CERTIFICATE OF APPROPRIATENESS

Proposal: Alteration: Porch, Siding, Ramp, Windows

ITEM E13 1418 Studewood St

August 3, 2023 HPO File No. 2023 0149

Approved Front (West) Elevation (Oct. 2019)

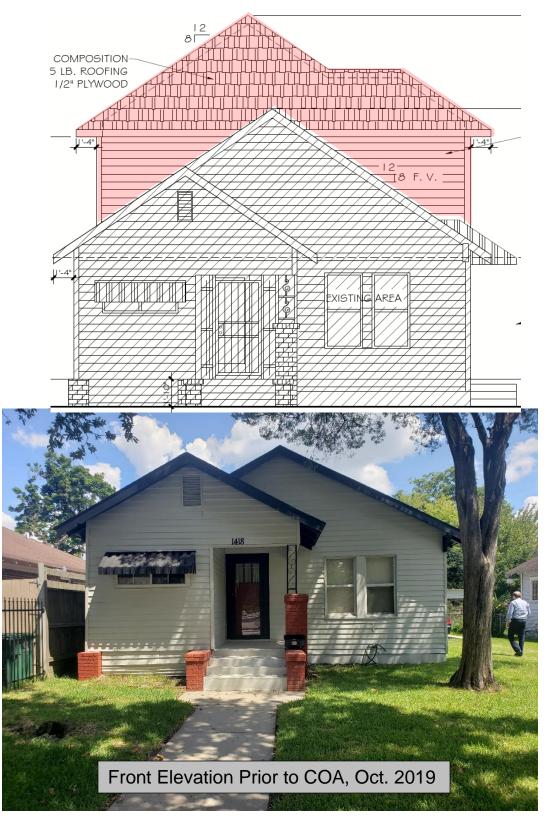
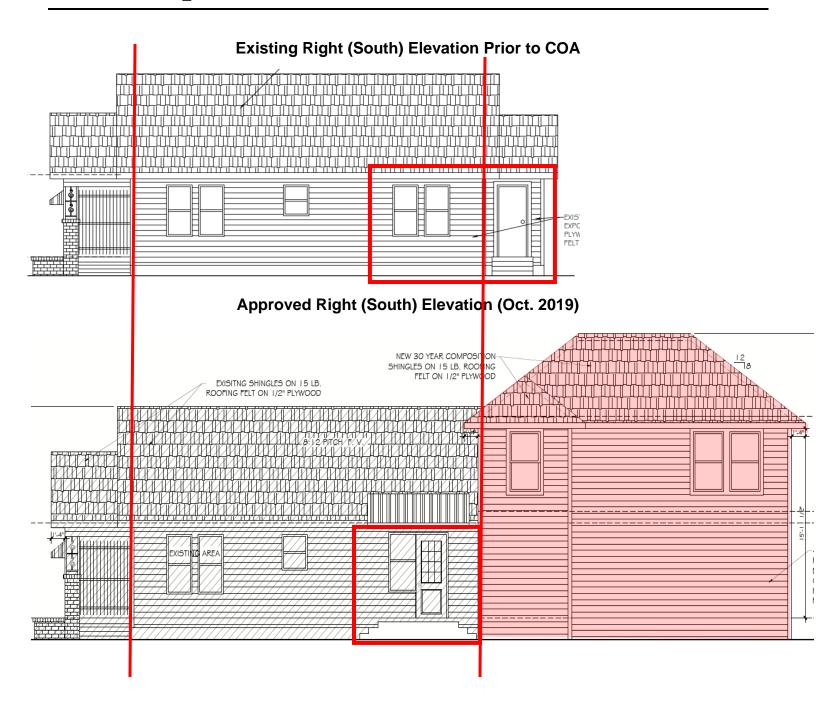
- Unpermitted work for the following:
 - Grass removal and concrete pads in place
 - Ramp installed
 - Alteration to porch
 - Alteration to windows on front elevation, left-hand side
 - Deviated from scope of work on right elevation from Oct. 2019 COA (location of door)
- A total of 22 red tag notices between 10-2020 to12-15-2022 with multiple follow-up visits by inspector
 - Most recent inspector follow-up on 7-18-2023

Recommendation: Denial of COA. Issuance of COR to remove brick skirting on front elevation on both sides of the brick porch steps; have slider windows on front elevation on left-hand side be inset and recessed with window trim matching historic windows; replace porch deck boards with 1"x4" tongue-n-groove, laid front to back; convert existing front porch column into a tapered column, and reorient ramp approach from the rear of the lot. Porch pedestals, front door, removal of awning on front elevation, placement of door on right elevation, and garage door to remain as completed.
